**RE: PEER REVIEW OF TRAFFIC AND TRANSPORT STUDY
PROPOSED ALTERATIONS AND ADDITIONS TO THE GLADESVILLE BRIDGE MARINA**

This letter documents TPPP's peer review findings, on behalf of the Local Action Group, on the traffic and transport study associated with the redevelopment of Gladesville Bridge Marina prepared by Colston Budd Rogers and Kafes (October 2019). TPPP also reviewed the Environmental Impact Study (EIS) as supplementary information to the redevelopment.

Figure 1: Existing Parking Areas

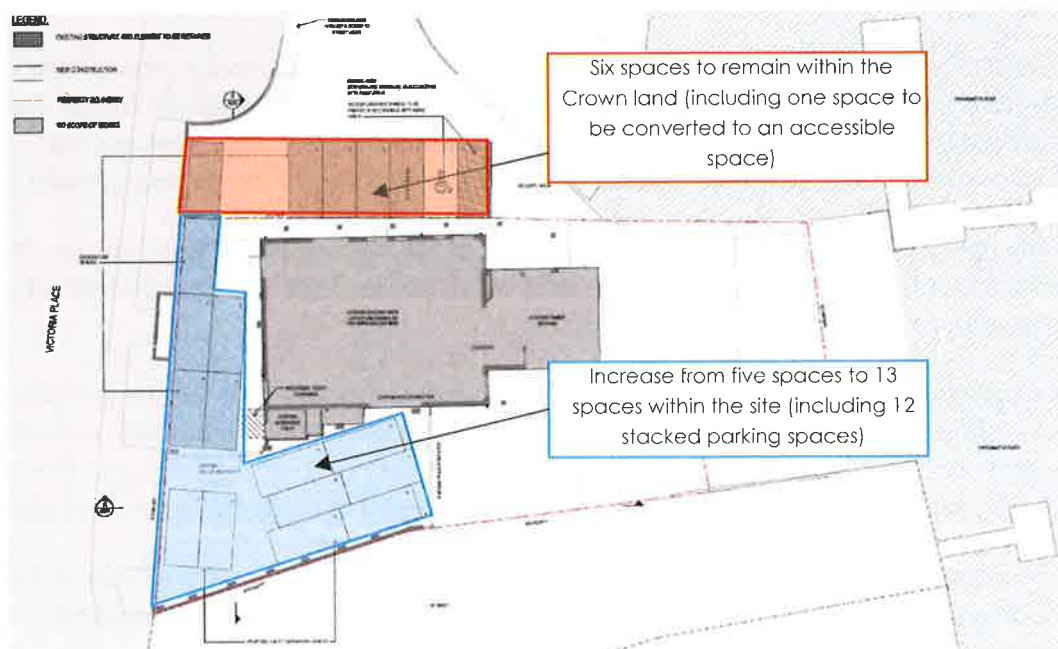
The subject site currently provides five approved parking spaces within the site (including four stacked parking spaces). The Local Action Group has advised that the car park within the Howley Park East Reserve is dedicated to public recreation and not approved for marina purposes. Any parking here would therefore be considered to be overflow off-site parking.

- The existing site provides five marked parking spaces, four of which are stacked parking spaces. Any parking on the ramp is unauthorised as any use of the slipway that is occurring as a result of the poorly designed parking on site which heavily relies on stacked parking.

- The five spaces within the Crown lease area are off-site parking which are shared with the public.
- The parking occupancy shown in Table 1 of the applicant report indicates surveyed parking demand (up to 12 spaces) cannot be contained within the site (five spaces) and would have overspilled onto the Crown land and further on the surrounding roads.
